HISTORIC AND DESIGN REVIEW COMPLIANCE AND TECHNICAL ADVISORY BOARD

March 22, 2024

HDRC CASE NO: 2024-108
ADDRESS: 215 MUNCEY
LEGAL DESCRIPTION: NCB 1660 BLK H LOT N 50 FT OF 15 & 16 ARB A15
ZONING: R-6, H
CITY COUNCIL DIST.: 2
DISTRICT: Dignowity Hill Historic District
APPLICANT: CUNNINGHAM TAYLYN & PAULINA
OWNER: CUNNINGHAM TAYLYN & PAULINA
TYPE OF WORK: Window replacement, fenestration modifications, door replacement, painting and exterior modifications
APPLICATION RECEIVED: March 07, 2024
60-DAY REVIEW: May 06, 2024
CASE MANAGER: Edward Hall

215 Muncey Request #2

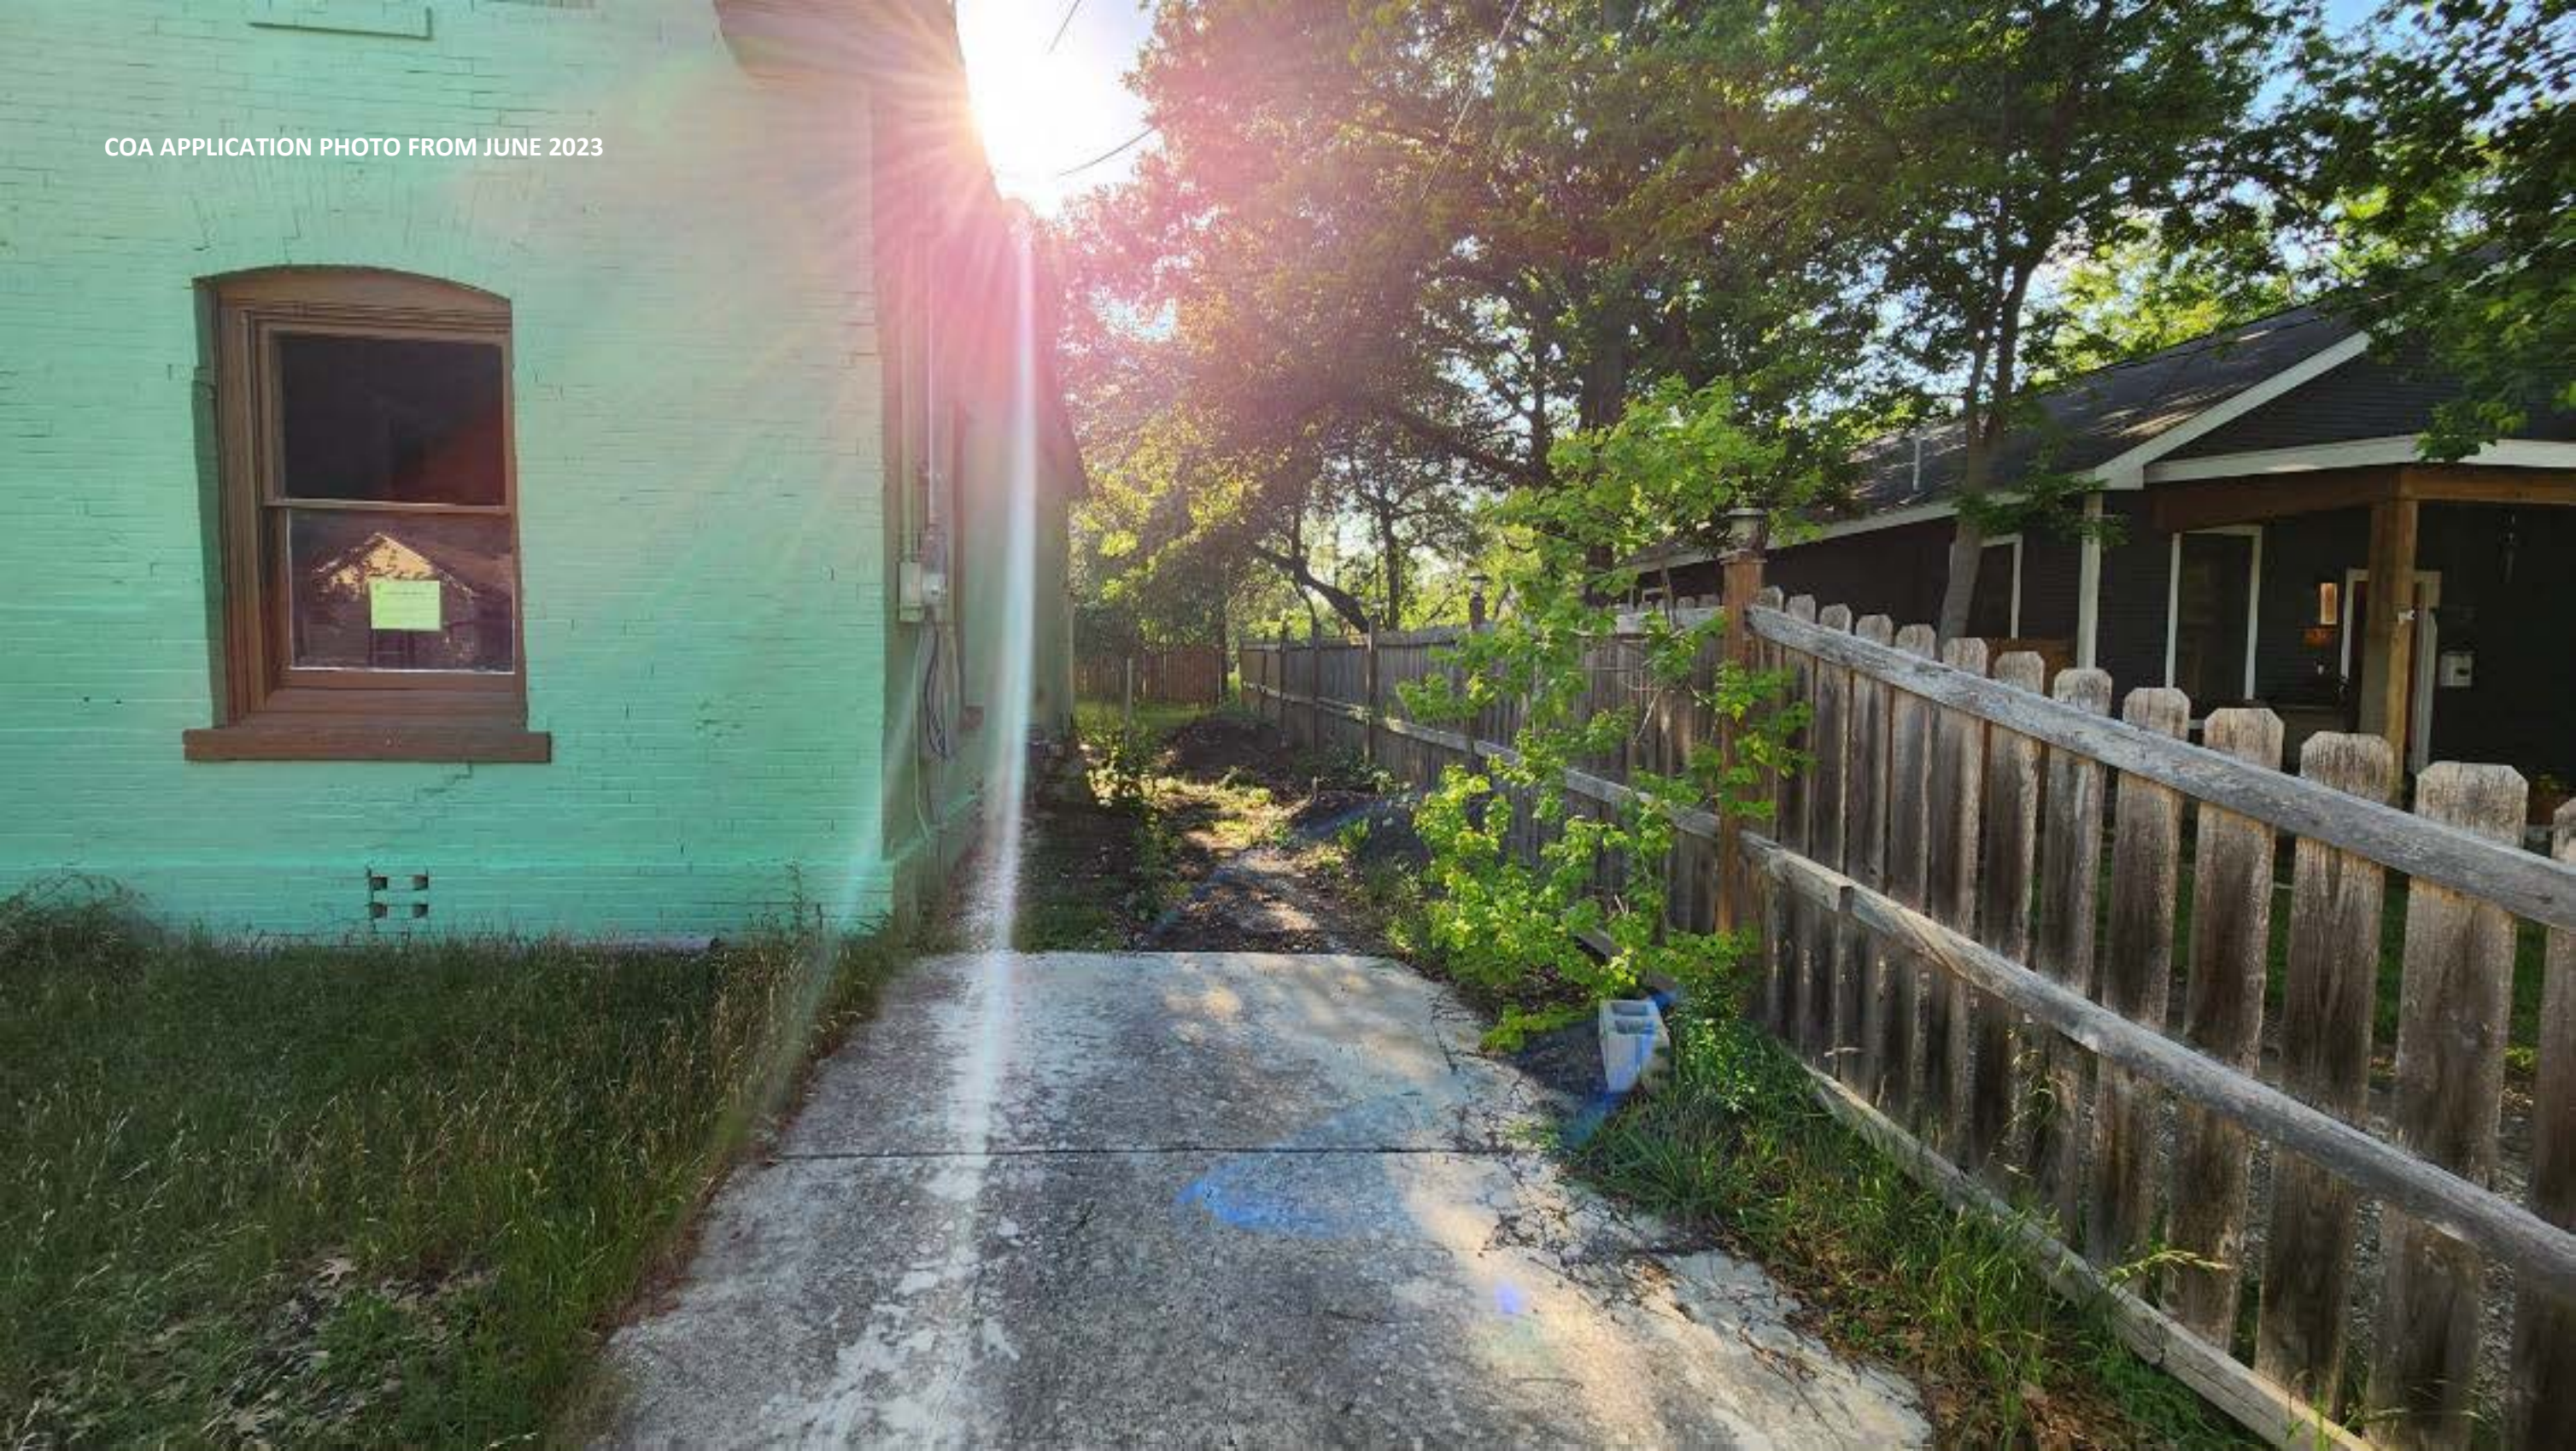
- e. WINDOW REPLACEMENT (Original Structure) – The applicant has proposed to replace eight (8) one over one wood windows with one over one vinyl windows. The Guidelines for Exterior Maintenance and Alterations 6.A.iii. notes that historic windows should be preserved. The Guidelines continue to note that when wood windows are beyond repair, they should be replaced with windows that match the historic or existing in terms of size, type, configuration, material, form, appearance, and detail. Staff finds the proposed vinyl replacement windows to be inconsistent with the Guidelines.

- Approval of replacement of old broken wooden windows with new quality vinyl windows from Window World San Antonio. 8x

2. Staff does not recommend approval of item #2, the replacement of eight (8) original wood windows with vinyl windows, based on finding e. Staff recommends the applicant repair and reinstall the original wood windows. If the original wood windows have been discarded, staff recommends the applicant install new or salvaged wood windows that match the profile of those that were removed. Replacement wood windows should be submitted to OHP staff for review and approval prior to purchase and installation.

Investigation Report

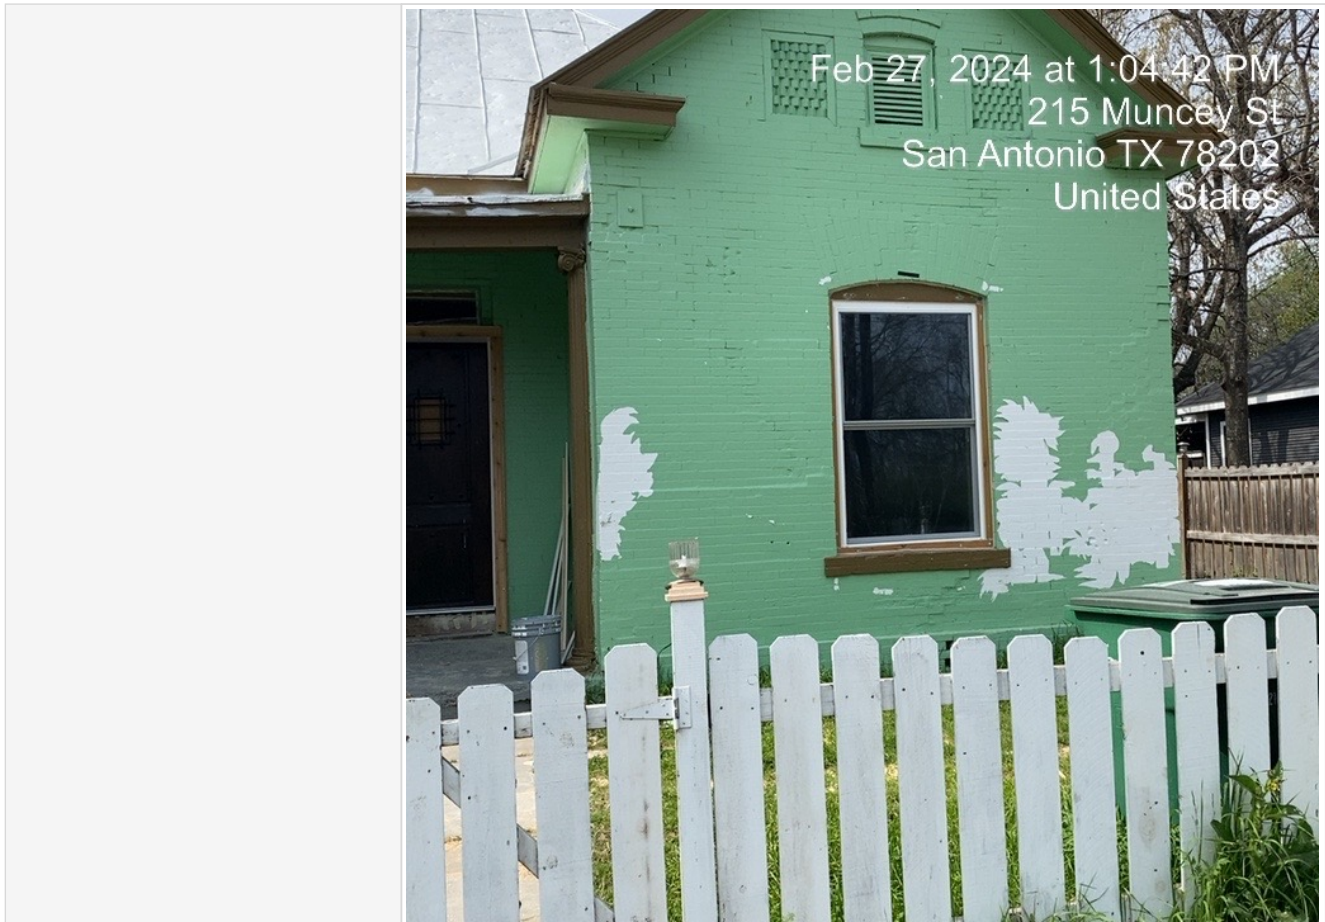
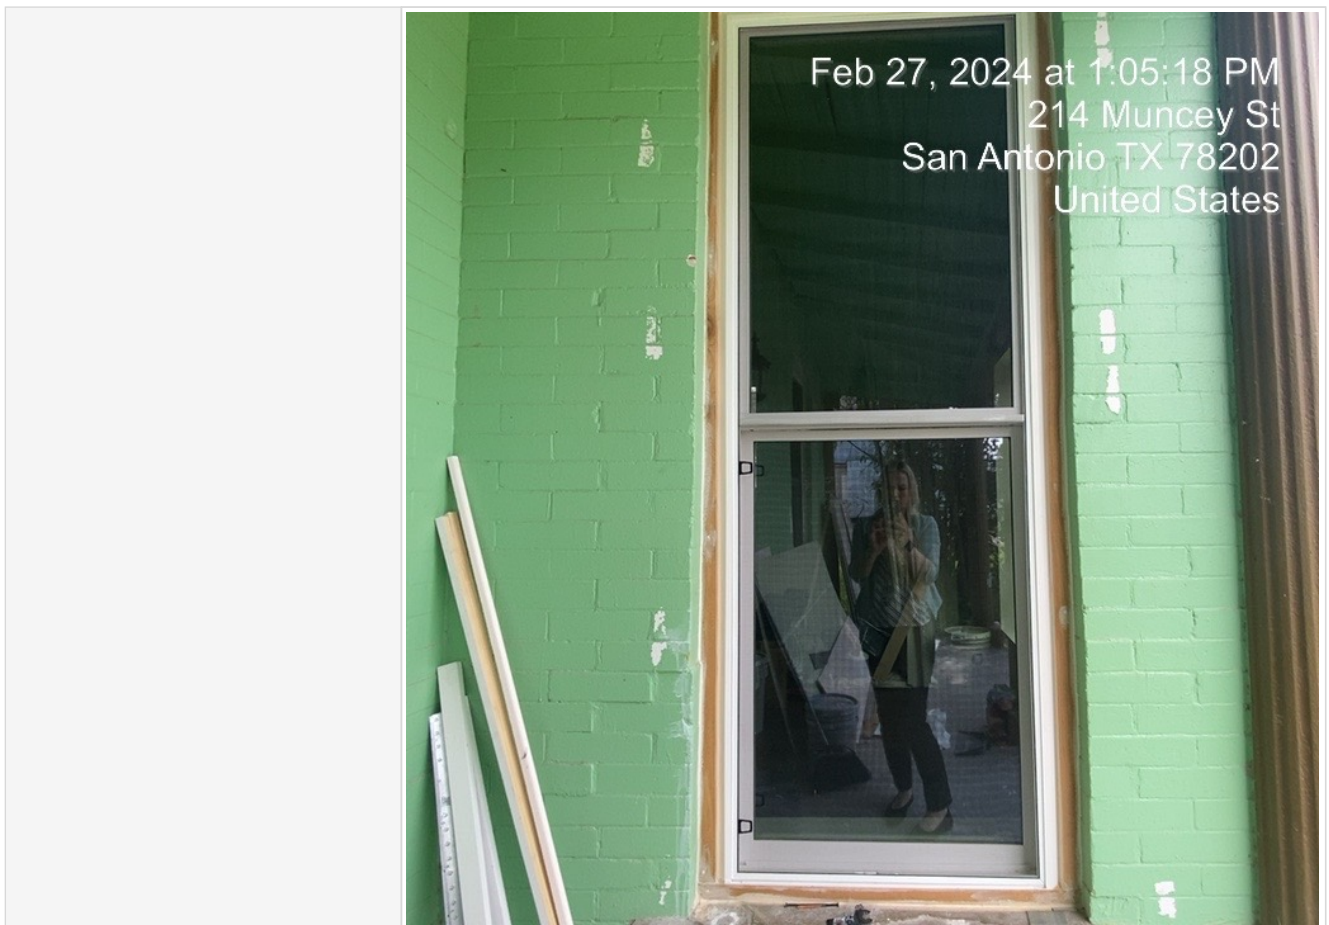
| Description of work | Replacement of previously existing wood windows with vinyl windows. Previously existing wood windows do not appear to be on site. |
